## **M**odification **B**ulletin

<b>M</b> odificat	tion <b>t</b>	<b>Ճ</b> ս	<u>lletin</u>		PAGE:	1/4
Model: Model L1a/L	.1b		Date	e: 29-Jan-0	3	No.: MH911001	
Modified Article: Addition of User's Guide and Quick Guide				Prepared	by: A.	Ishiyama	
From: Technical Sei	rvices Sec. Service Planning D	ept.					
Reason for Modification:	<ul><li>☐ Parts catalog correction</li><li>☐ To facilitate assembly</li><li>☐ Part standardization</li></ul>	☐ Vendor change ☐ To improve reliability ☐ Other ()		☐ To n	neet standards )		
Modification	All new parts are available from	om the fire	st ma	ss productio	n.

Model: Model L1a/L1b Dat			Date	e: 13-Mar-03		No.: MH911002
Modified Article: EMI Regulation			Prepared by: A. Ishiyama			
From: Technical Services Sec. Service Planning Dept.						
Reason for	Parts catalog correction	☐ Vendo	or ch	<u> </u>		
Modification:	☐ To facilitate assembly	☐ To im	prove	e reliability	(EN	11)
	☐ Part standardization	Other ()				
Modification	After old parts have become	After old parts have become out of stock.				
Schedule:

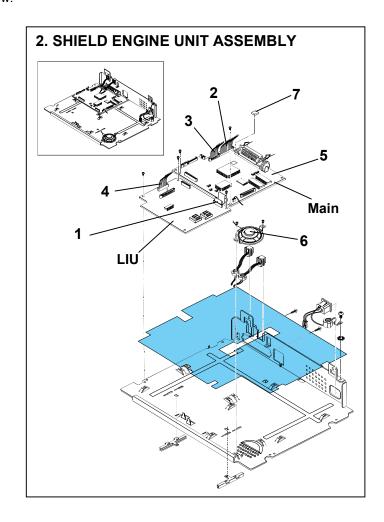
To provide additional latitude for satisfying EMI regulations, a ferrite core has been added to the Power Pack Harness, Monitor Speaker and Quenching Lamp, and a Rubber Foot has been added to the main board oscillator.

Old part	New part	Description	Q'ty	Int	Section	Index	Note
number	number		_				
H9119517	H9119517A	Harness – Power Pack	1→1	O/O	2	3	
H9119521	H9119571	Monitor Speaker	1→1	O/O	2	6	
H9119533	H9119572	Quenching Lamp	1→1	O/O	4	10	
	H9119573	Rubber Foot	0→1	-/-	2	7	1

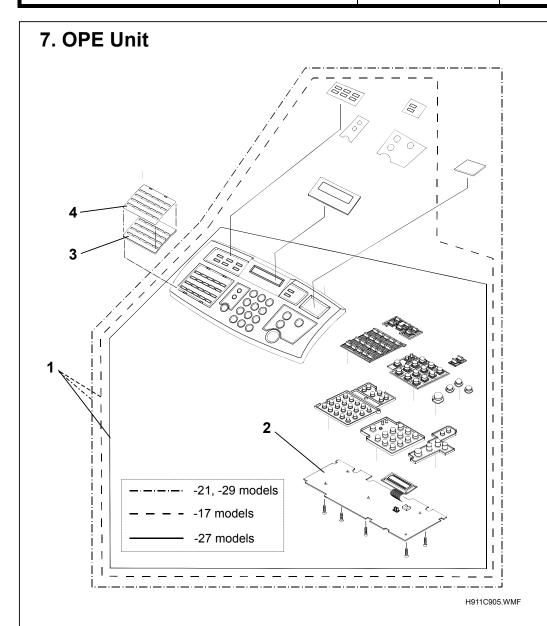
Incorrect	Correct	Description	Q'ty	Int	Section	Index	Note
part number	part number						
H9119540	H9119574	Op-Port Unit – Upper: Asia	1→1		7	1	1
	H9119575	Quick Dial Sheet	0→1		7	3	2
	H9119576	Quick Dial Sheet Cover	0→1		7	4	3

<H9119580: Open Button - Scanner >

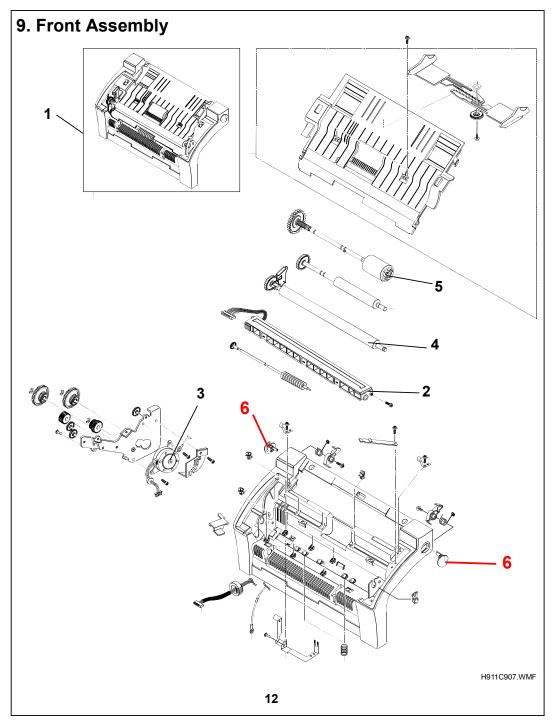
Incorrect	Correct	Description	Q'ty	Int	Section	Index	Note
part number	part number						
	H9119578	Carton Box – L1a China	0→1		1	*	1
H9119519	H9119579	PCB - Main Board: 1a China	0→1		2	5	2
	H9119580	Open Button - Scanner	0→1		9	6	3

<8. H9119581: Tray Guide Rail>

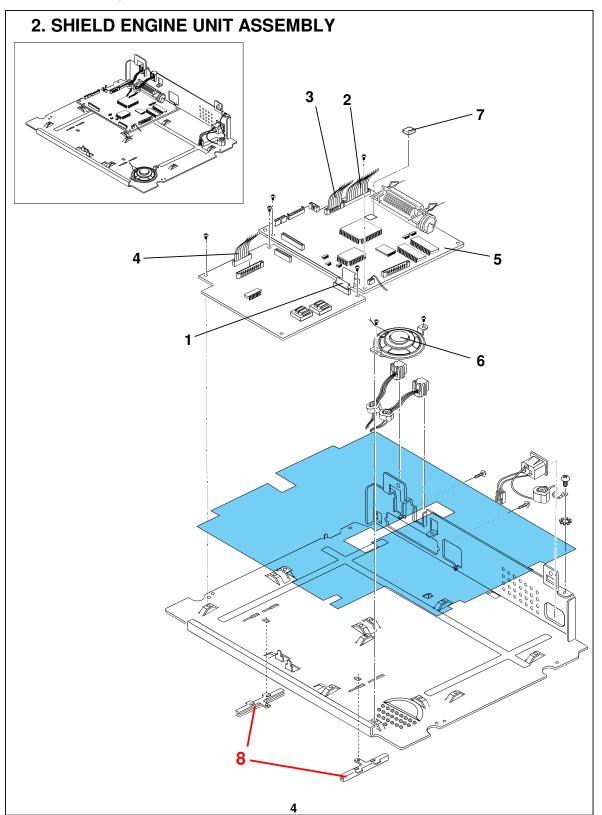
Old	New	Description	Q'ty	Int	Section	Index	Note
part number	part number	mber					
	H9119581	Tray Guide Rail	0→2		2	8	1
	H9119582	Pressure Roller Bushing	0→2		4	12	1
	H9119583	Pressure Roller Spring	0→2		4	13	1
	H9119584	Pressure Roller Holder	0→2		4	14	1

<4. H9119518: Harness-NCU >

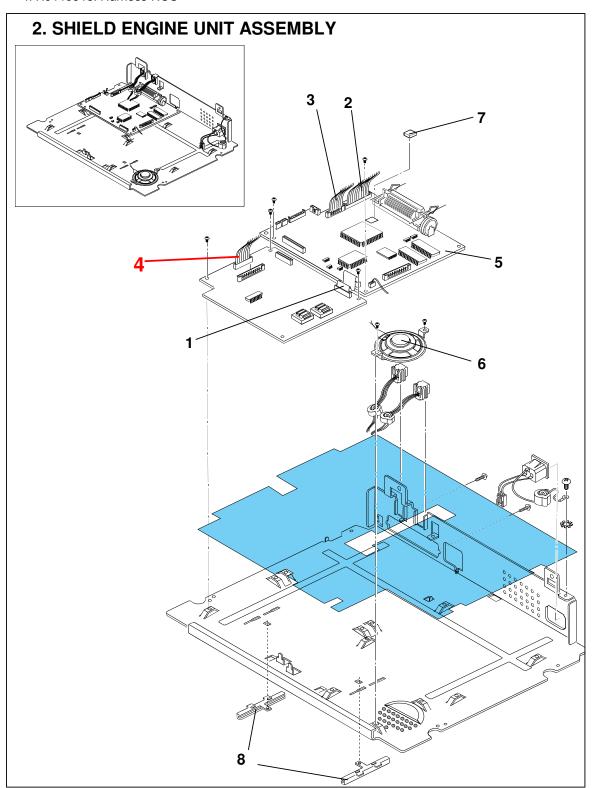
Please delete the following item from your Parts Catalogs, as it was mistakenly registered with service parts (corresponding illustration correction on the next page).

<b>Part Number</b>	Description	Q'ty	Int	Section	Index	Note
H9119518	Harness-NCU	1→0		4	4

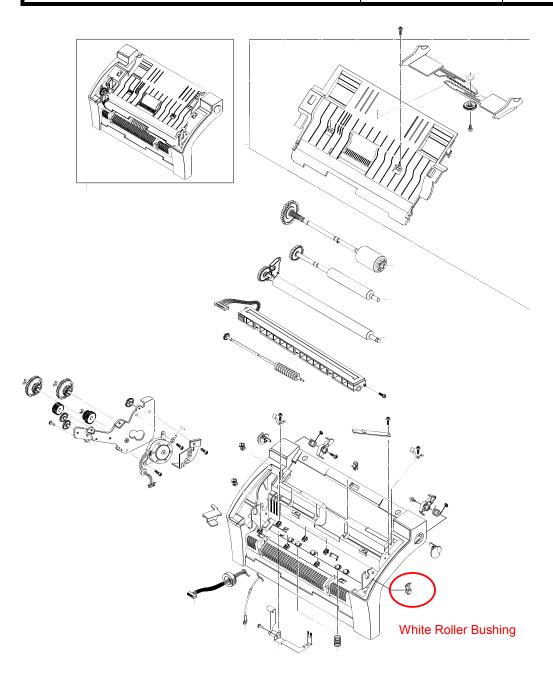
The following part has been added per a request from the field (see the next page for the corresponding illustration).

Old part number	New part number	Description	Q'ty	Int	Page	Index	Note
	H9119587	White Roller Bushing	0→1	-	13	7

#### 2. SHIELD ENGINE UNIT ASSEMBLY

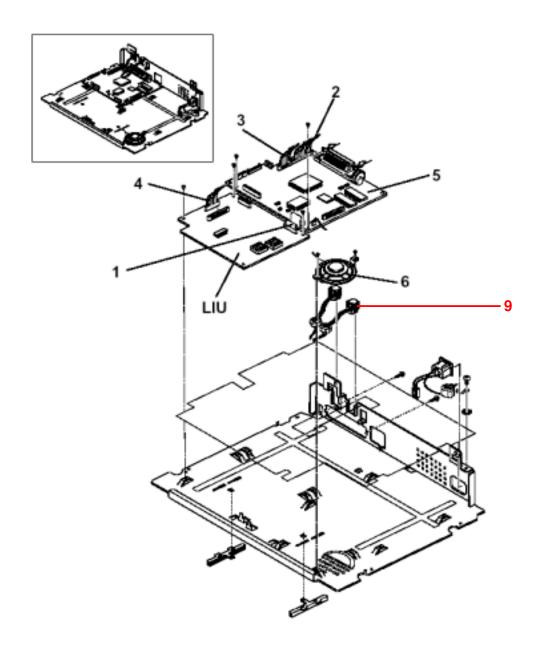
These parts were added as per request from the field (See the illustration on the next page).

Old part number	New part number	Description	Q'ty	Int	Page	Index	Note
	H9119585	Harness – LINE / EXE	0→1	-	4	9	*1
H9119519	H9119586	PCB - Main Board : 1A	1→1	O/O	4	5	*2
	H9119588	Lock - Scanner L	0→1	-	13	8	
	H9119589	Lock – Scanner R	0→1	ı	13	9

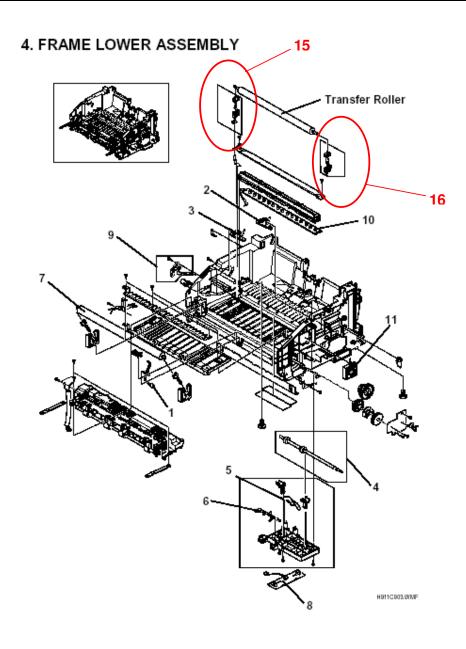
New part number	Description	Q'ty	Int	Page	Index	Note
H9119590	Transfer Roller Bushing L	0→1	-	7	15	-
H9119591	Transfer Roller Bushing R	0→1	-	7	16	-

**Change:** Parts added **Reason:** Request from the field.

#### 4. FRAME LOWER ASSEMBLY

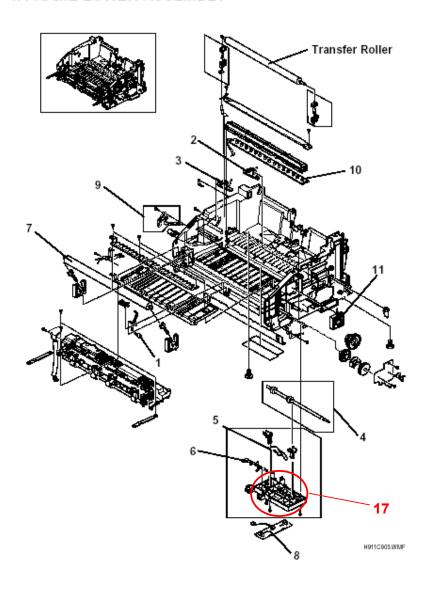
New part number	Description	Q'ty	Int	Page	Index	Note
H9119593	BASE – PAPER FEED	0→1	-	7	17	-

**Change:** Part added **Reason:** Request from the field.

#### 6. PLATE-UPPER UNIT ASSEMBLY

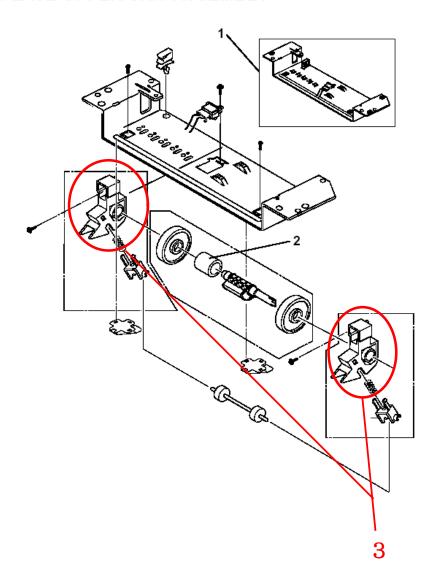
New part number	Description	Q'ty	Int	Page	Index	Note
H9119594	PAPER PICK-UP HOLDER	0→2	-	9	3	-

Change: Part added

#### 3. ENGINE ASSEMBLY

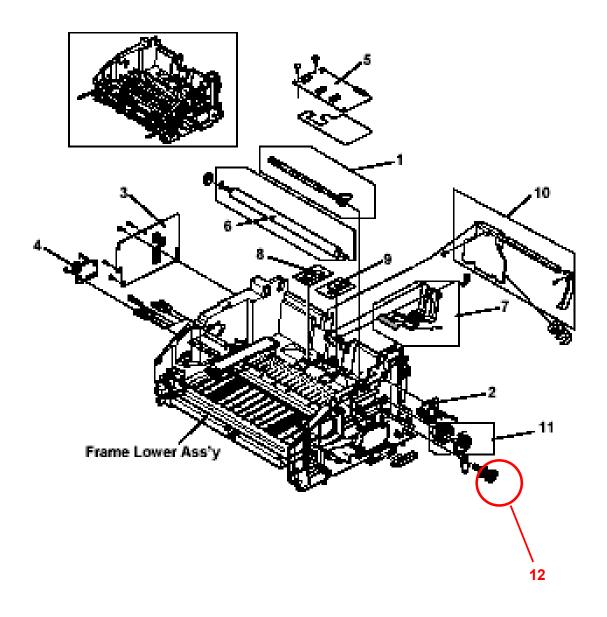
New part number	Description	Q'ty	Int	Page	Index	Note
H9119595	PAPER FEED GEAR	0→1	-	5	12	-

**Change:** Part added **Reason:** Request from the field.

6. PLATE-UPPER UNIT ASSEMBLY

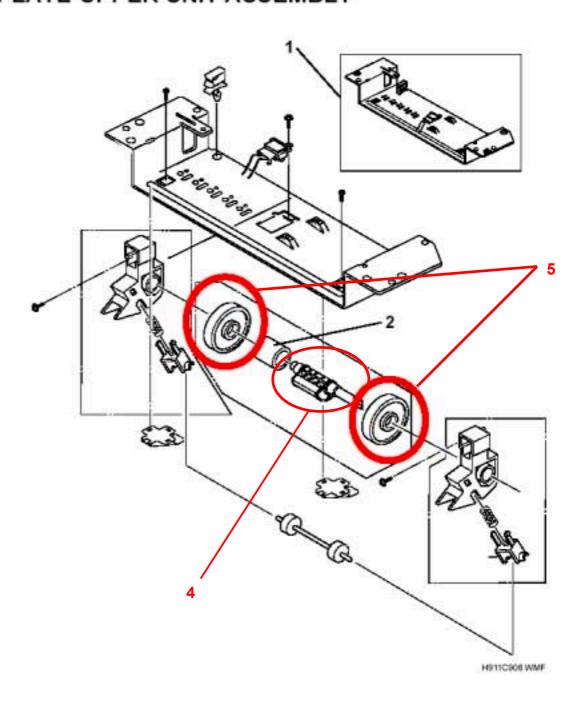
New part number	Description	Q'ty	Int	Page	Index	Note
H9119596	PICK UP SHAFT	0→1	-	9	4	-
H9119597	PICK UP IDEL	0→1	ı	9	5	-

**Change:** The parts were added. **Reason:** Request from the field.

Incorrect part number	Correct part number	Description	Q'ty	Int	Page	Index	Note
H9119587	H9119598	WHITE ROLLER BUSHING	1->1	-	12	7	-

**Change:** The part number was corrected.

#### 9. FRONT ASSEMBLY

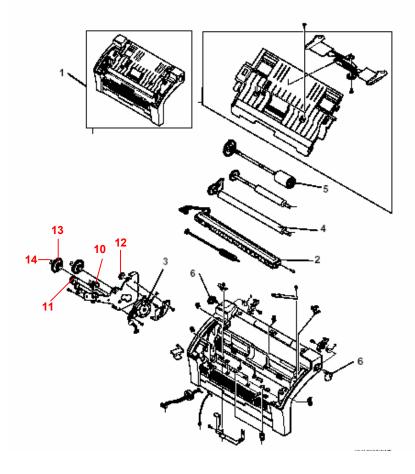
Part Number	Description	Q'ty	Page	Index	Note
H9119599	GEAR 39/20	1	13	10	-
H9119600	GEAR IDLE 30	1	13	11	-
H9119601	GEAR UDLE 25	3	13	12	-
H9119602	GEAR TRANS	2	13	13	-
H9119603	C-RING	3	13	14	-
H9119604	GEAR-IN 47	1	7	18	-
H9119605	HUB GEAR	1	7	19	-
H9119606	GEAR-OUT 47	1	7	20	-
H9119607	GEAR 83/35	1	7	21	-

Change: These parts were added.

#### 3. ENGINE ASSEMBLY

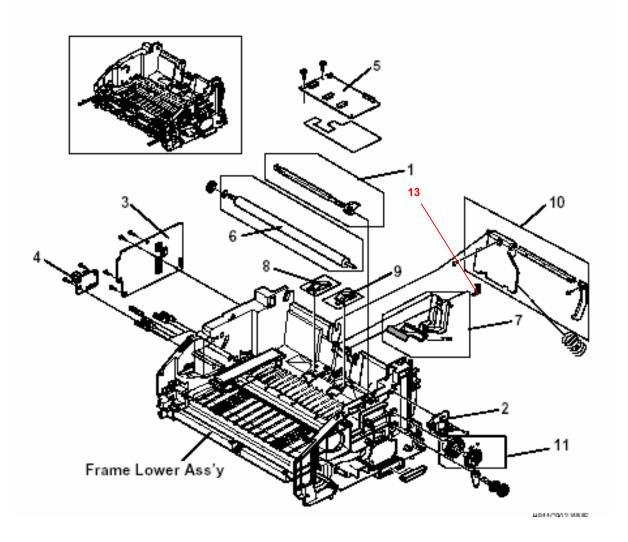
Part Number	Description	Q'ty	Page	Index	Note
H9117500	CAP – FRICTION PAD	1	5	13	-

Change: This part was added.
